Response to Human Factors Engineering Control Room Design Review/Audit

**LOUISIANA POWER & LIGHT COMPANY
WATERFORD SES UNIT NO. 3**

DECEMBER 1982 — REV. 1

SUBJECT: Waterford 3 SES Unit 3
Control Room Design Review

FIGURE 2.1-1

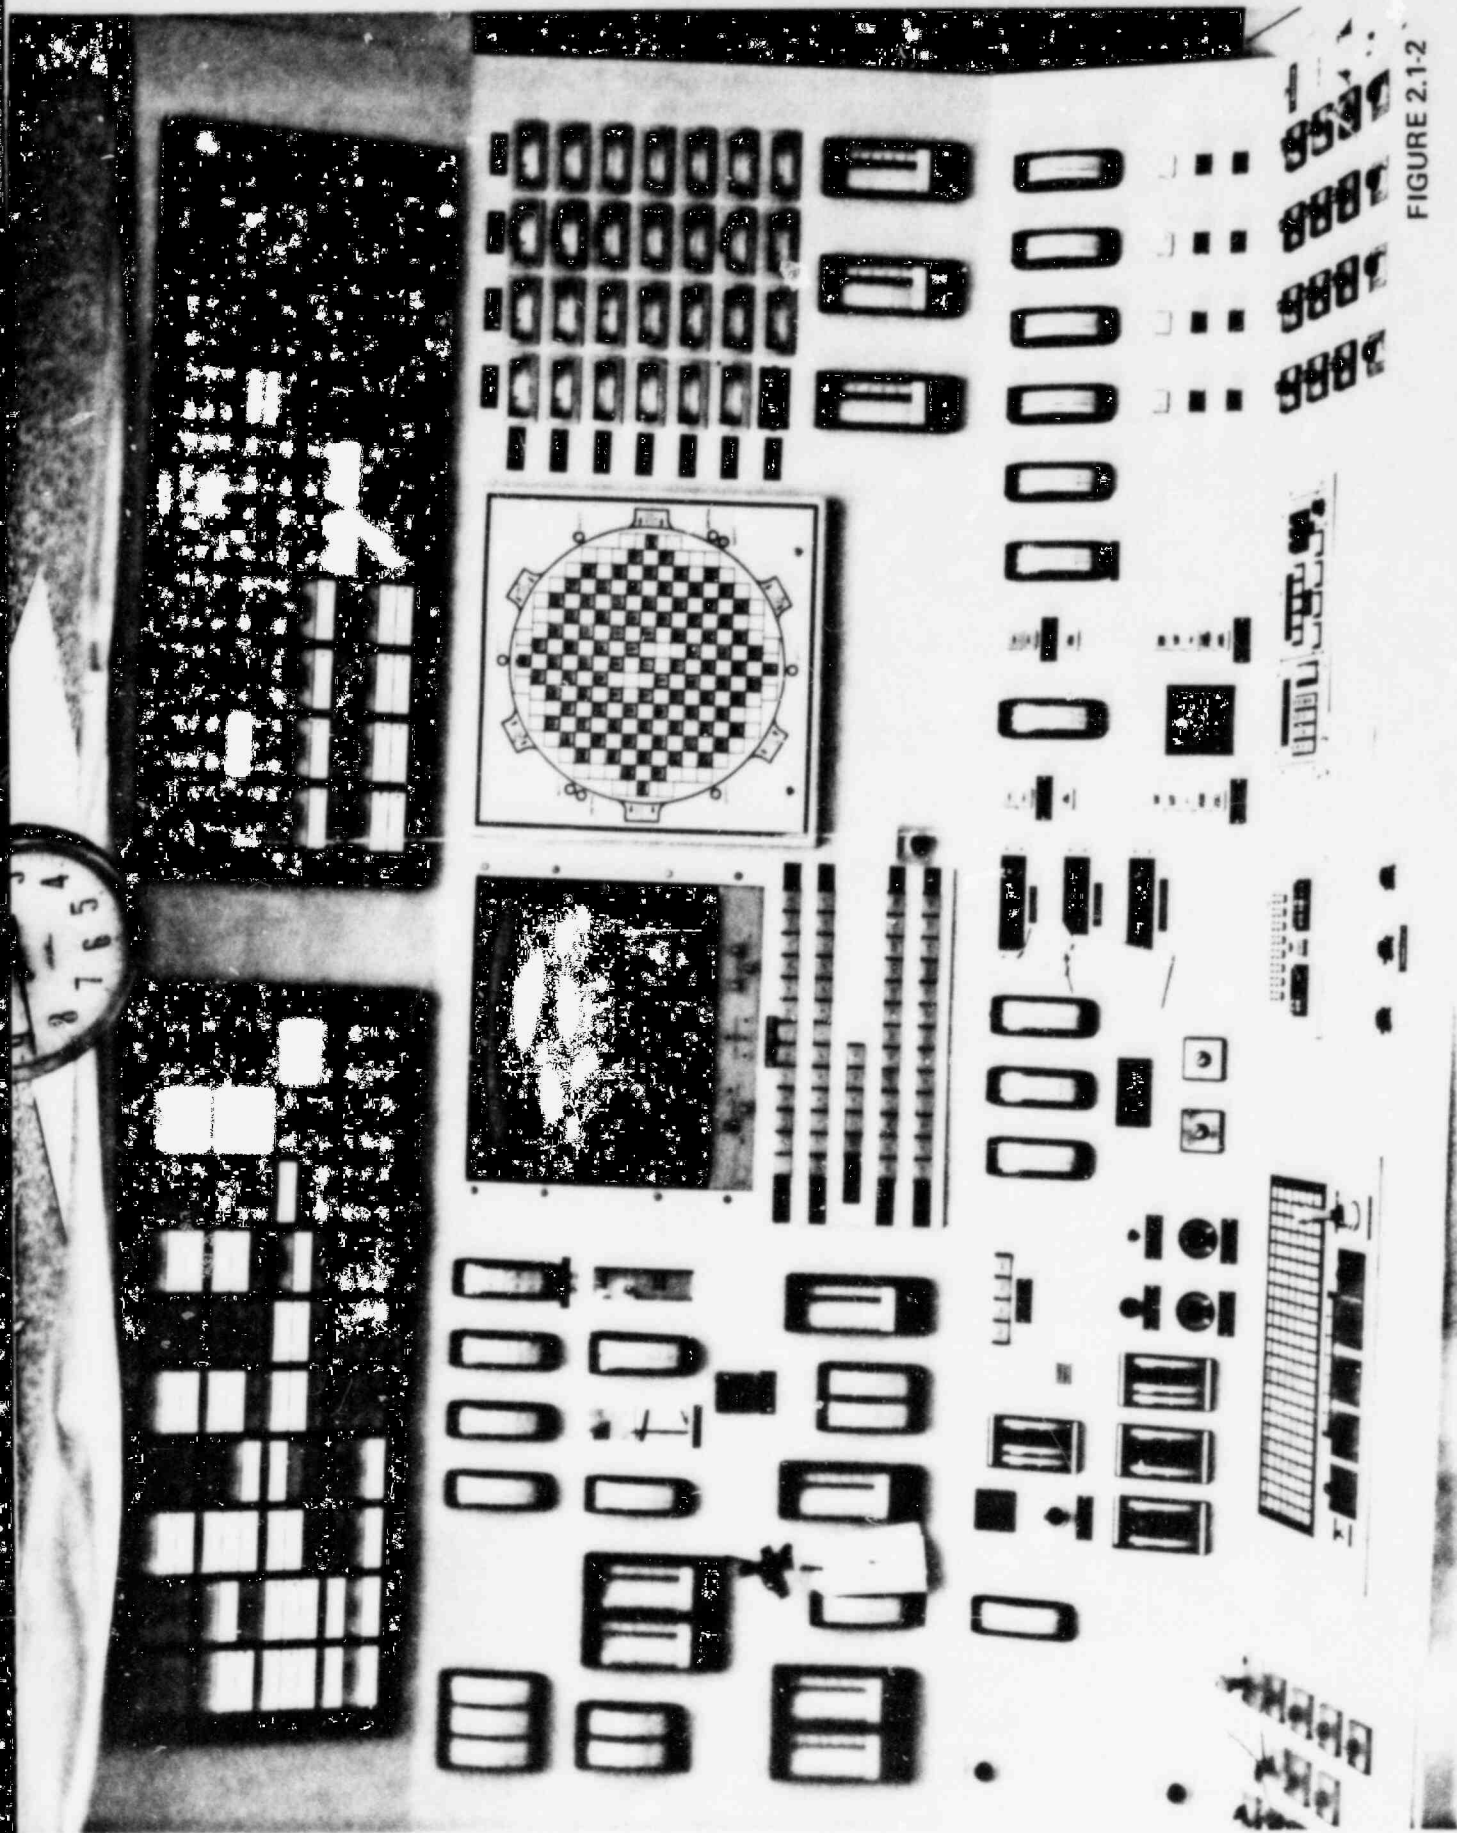
Response

Clear labels are now provided for the channel selector switch as can be seen on Figure 2.1-1. A scale will be provided for the Audio count rate selector switch by Hot Functional Testing. This scale will show the audio count rate multipliers (e.g. x 1, x 10, x 10², x 10³, x 10⁴)

FIGURE 2.1-2

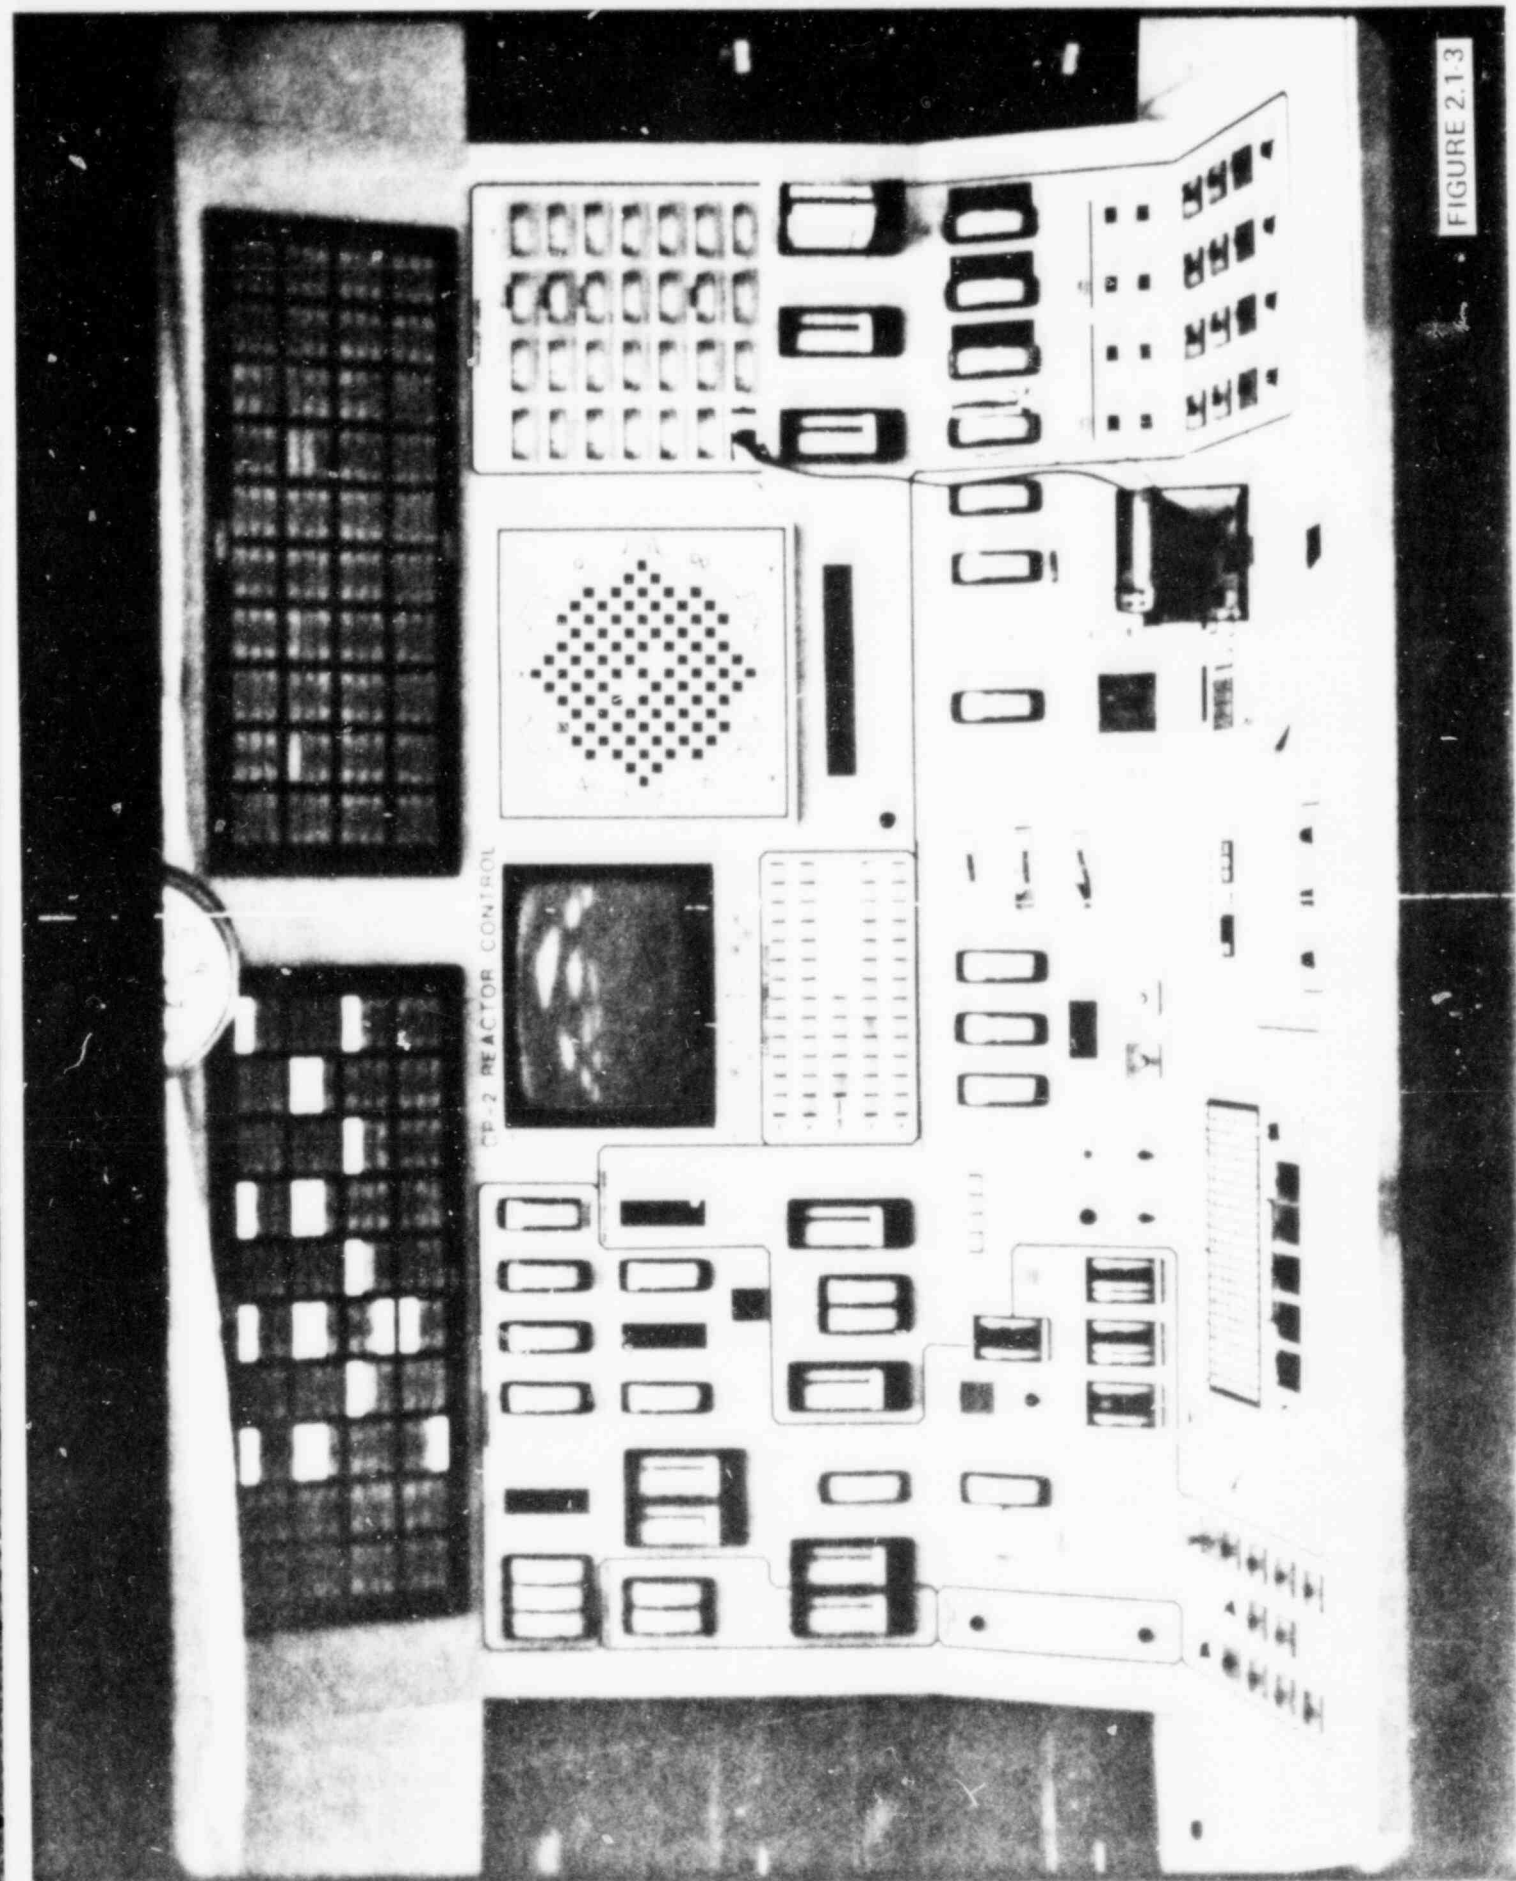
"The log scale (on the startup neutron flux level meter) appears inverted - possibly an assembly error. Major divisions are correct; intermediate and minor (divisions) are not."

The meter scale has been corrected (refer to Figure 2.1-3).

FIGURE 2.4-1

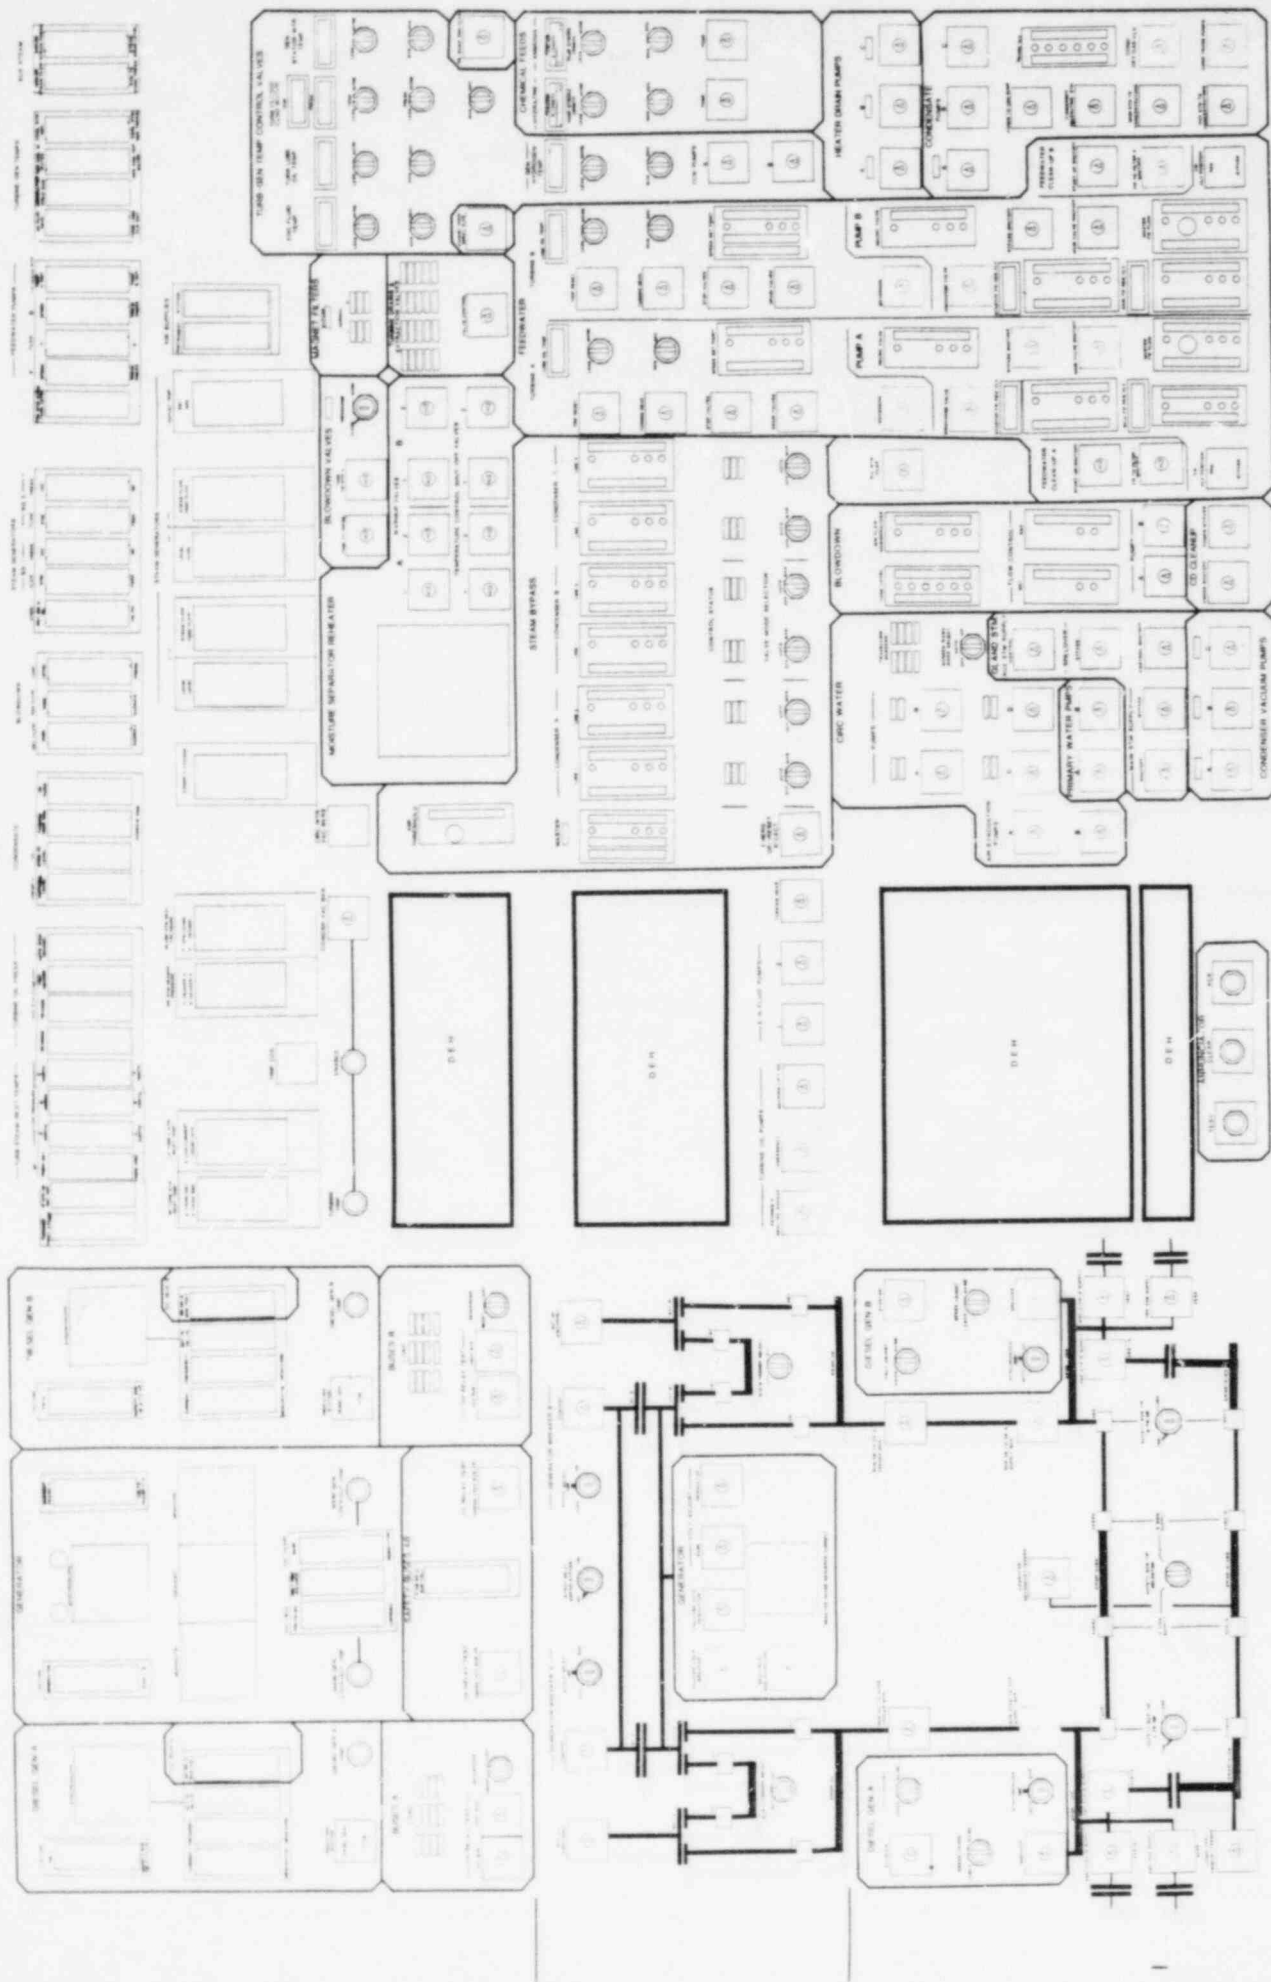
NRC Review Team Comment: Isolation valve controls are on CP-8.

Individual steam generator pressure indicators are being added to CP-1 (DCN-IC-1014).

CONTROL ROOM LAYOUT, LOCATING ANNUNCIATORS AND ALARM ZONES

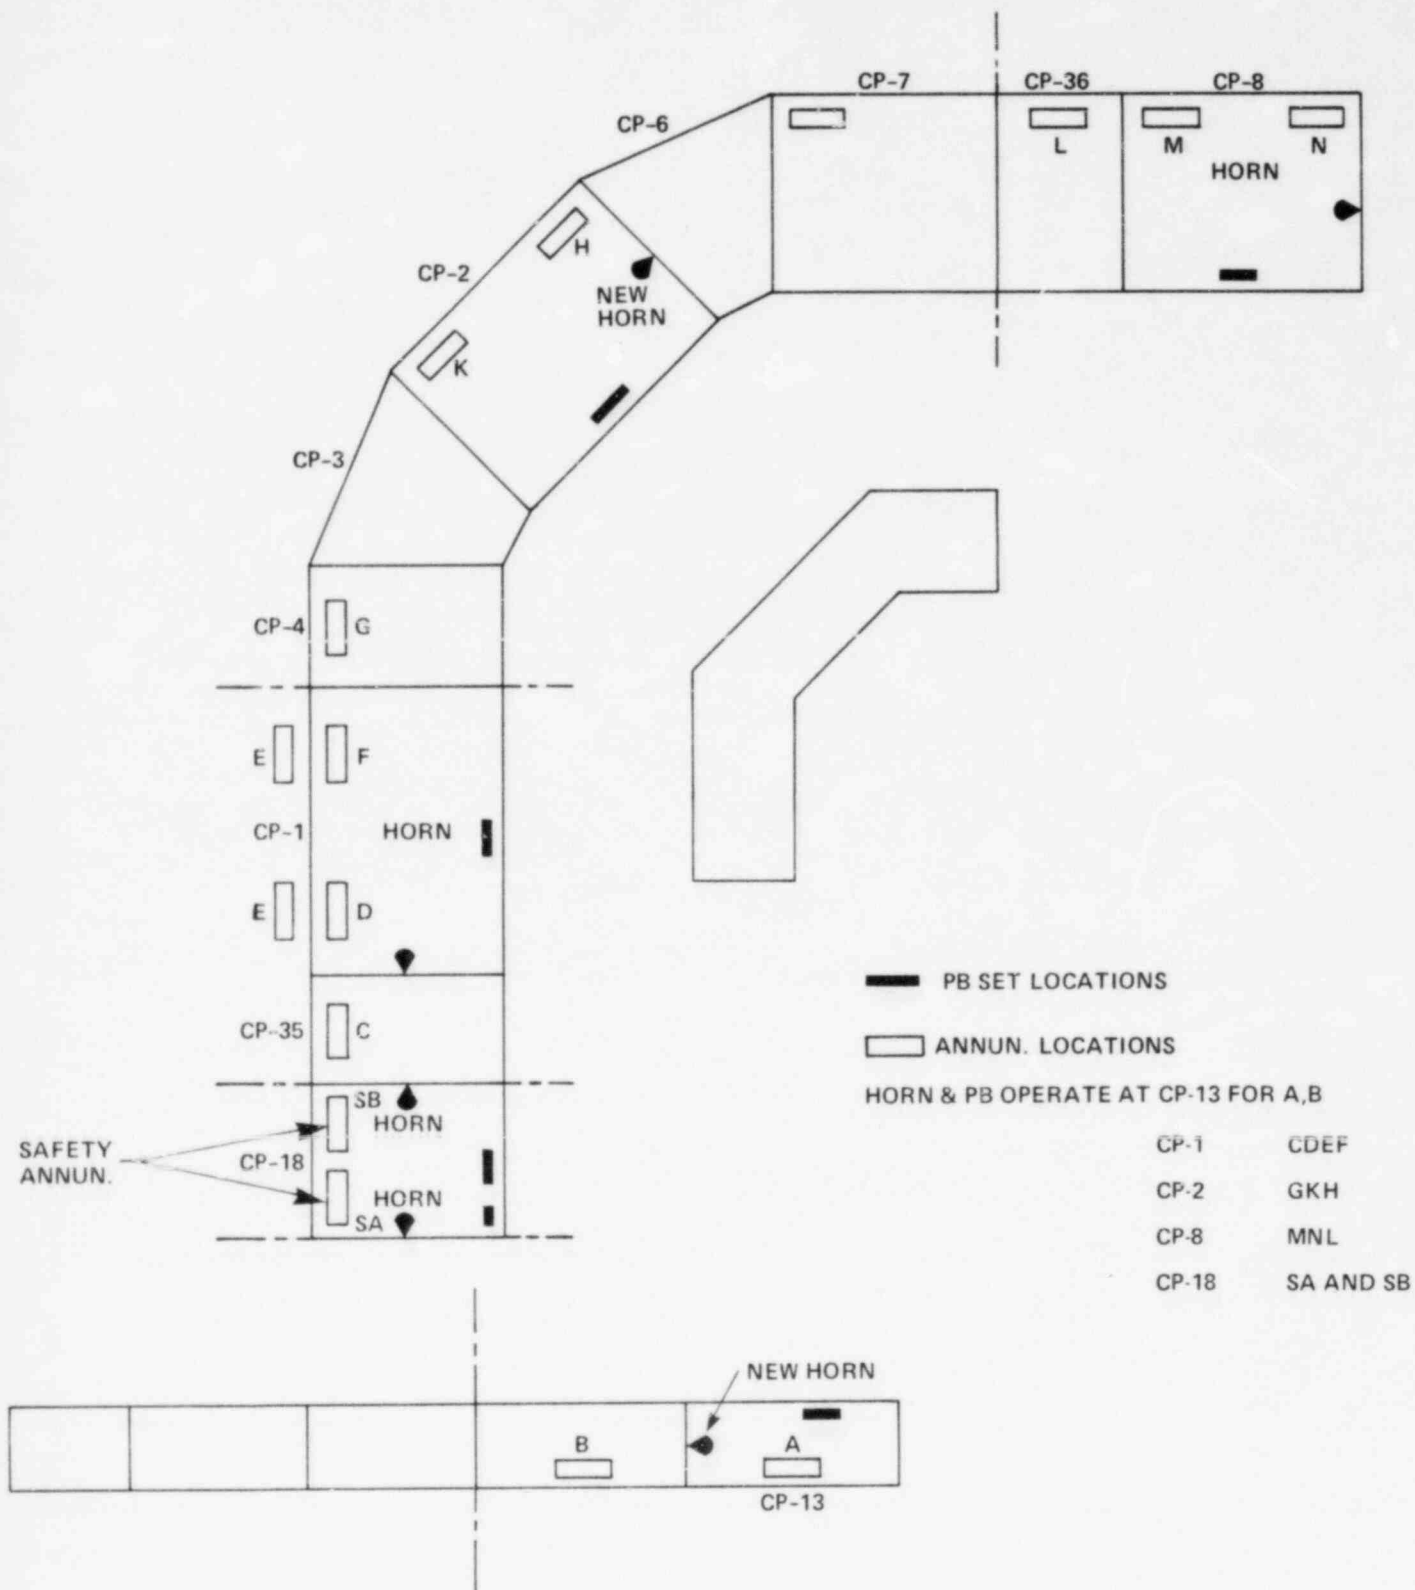
"The Annunciators audible alarm systems do not provide sufficient localization cues to direct the operator to the appropriate alarm source (e.g., CP-1, CP-2, CP-8)."

Two additional horns will be added to the main annunciator system (on panels CP-13 and CP-2, respectively) and the circuits will be modified prior to Licensing to provide four alarm zones, each with its own horn and its own set of control pushbuttons. Refer to Figure 2.11-1. | 1

FIGURE 2.11-2

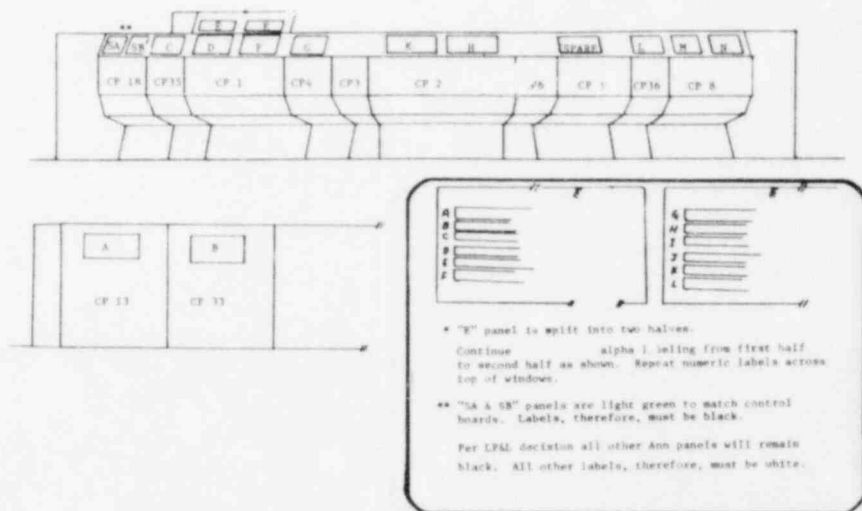
1. "Annunciator panels are not labeled for cross-reference to Alarm Procedures and I&C use".
2. "Windows are not coded for cross-reference to Alarm Procedures and I&C use."
3. "Existing window codes on drawing/diagrams are Numeric-Numeric (X,Y) in a row-column scheme. If operator (or I&C Tech) identifies window by Column-row (i.e., Y,X) he will locate incorrect Alarm Procedure or I&C document/wiring. The X,Y convention fits human stereotypes."

Current method of window identification follows the method of word identification on a printed page (identification of line followed by identification of word position in that line). In order to achieve a viable cross-reference to alarm procedure and for I&C use, additional labeling will be provided where required. LP&L will add alpha-numeric annunciator labels prior to fuel load. Refer to Figure 2.11-2.
